LIC-16-0012
April 4, 2016

Subject: License Amendment Request (LAR) 16-01; Revised Commitment to Modify FCS Plant Systems as Part of the Implementation of NFPA 805

OPPD's Evaluation of Proposed Change

Revised Commitment to Modify FCS Plant Systems as Part of the Implementation of NFPA 805

FIGURE 1 FCS 125 VDC Distribution System

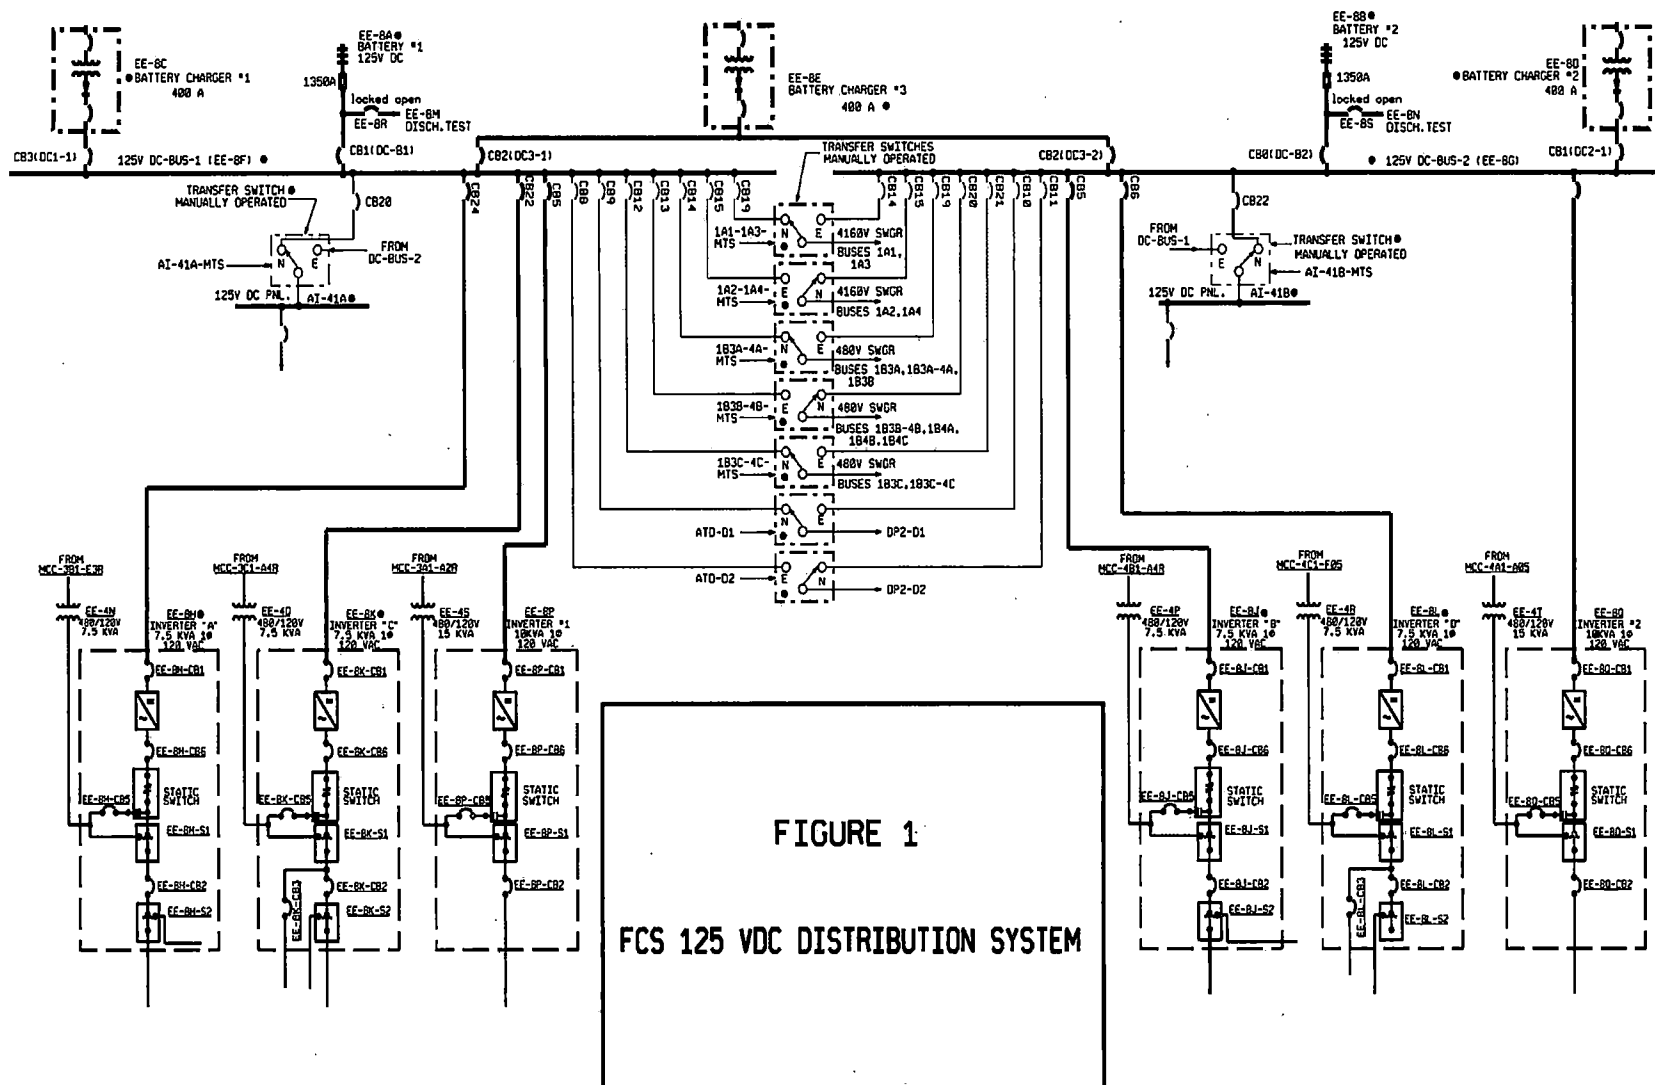
1. Additional Electrical Isolation between Battery No. 1 and DC-Bus-1 (REC-119)
2. Additional Electrical Isolation between Battery No. 2 and DC-Bus-2 (REC-120)

Commitments to implement REC-119 and REC-120 are proposed to be withdrawn due to the fact that they are not necessary to meet the performance requirements of NFPA 805 and have potentially adverse impact on the performance of the station batteries. After the elimination of REC-119 and REC-120, the remaining commitments (including alternative implementation of items REC-111 and REC-137 as discussed in Reference 6.5) continue to ensure that the fire protection program:

As discussed above, the REC-119 proposed modification is not needed to reduce overall risk or to meet deterministic requirements. Nevertheless, consideration was given to whether this modification remains desirable as an enhancement. It was concluded that the proposed isolation fuses have a potential negative impact, and therefore are not desirable. Specifically, in order to serve their intended function during battery room fires, the fuses would need to be sized such that they would have the potential to open in certain non-fire scenarios in which it would not be desirable for the fuses to open. This could adversely affect the response to these non-fire scenarios.

Installation of isolation fuses as originally proposed would also require the addition of diodes to prevent the fuses from opening during normal DC bus operation. The addition of diodes would result in increased voltage drop from the batteries to associated DC loads, on the order of 1 to 2 volts. Under the most adverse conditions anticipated for battery operation, there is currently little design margin for any additional voltage drop. Consequently, it is possible for the proposed modification to cause an unacceptable voltage drop during design basis battery operating conditions.

The committed modification is concluded to be unnecessary and potentially adverse. Therefore, REC-119 is proposed to be eliminated. The detailed justification for these changes is discussed in the Technical Evaluation section.

A revision to the compliance analysis no longer credits the original proposed modifications to install additional electrical isolation for the station batteries but now relies on an action performed in the control room to maintain power to important loads that may be impacted by a battery room fire. The action involves restoration of power to a main control room DC distribution panel by the manual operation of the panel transfer switch. Aside from this control room action, it is recognized that the action to manually isolate the battery from the bus in the field is likely to occur; however, this action will not be credited for NFPA 805 nor will it have any adverse impact on safe shutdown. If the field action to isolate the faulted battery from the bus is completed and the DC bus remains energized (i.e. the battery charger continues to supply bus loads), it will preclude the need for control room operators to use the AI-41A or AI-41B transfer switches located in the control room.
